PRODUCT CHANGE NOTIFICATION (PCN)

A-MCUP-80010 MODULAR CABLE

PCN 20220425_A-MCUP-80010

A-MCUP-80010		OLD VERSION		A-MCUP-80010		NEW VERSION	
Apprearence				Apprearence

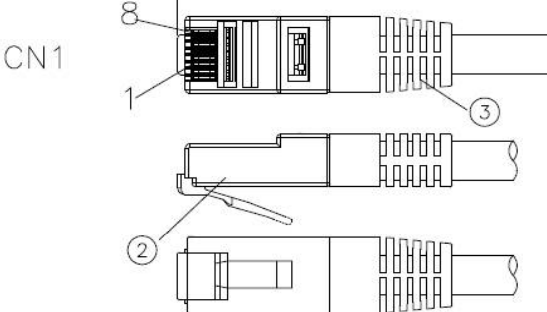
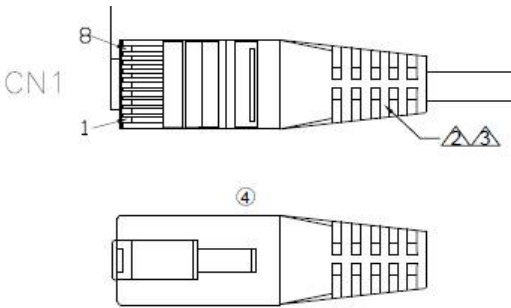
BOM				BOM			
③	Molding PVC	2	Molding PVC 45P	④	Molding PVC	2	Molding PVC 65P
②	RJ45 CONN	2	RJ45 8P8C,Two Fork gold plated contacts 3u" gold	④	RJ45 CONN	2	RJ45 8P8C, contacts 3u" gold-plated Un-shielded PC UL94V-2
①	CABLE	1	UTP(26AWG*x1PR)*4+PVC OD:4.9±0.2mm	④	CABLE	1	CAT 5E U/UTP(26AWGx1PR)*4+PVC Jacket OD:4.9±0.2mm
NO.	NAME.	Q'TY	SPECIFICATION	NO.	NAME.	Q'TY	SPECIFICATION
FOR DETAIL, PLEASE TAKE ATTACHED NEW DRAWING: FOR REFERENCE
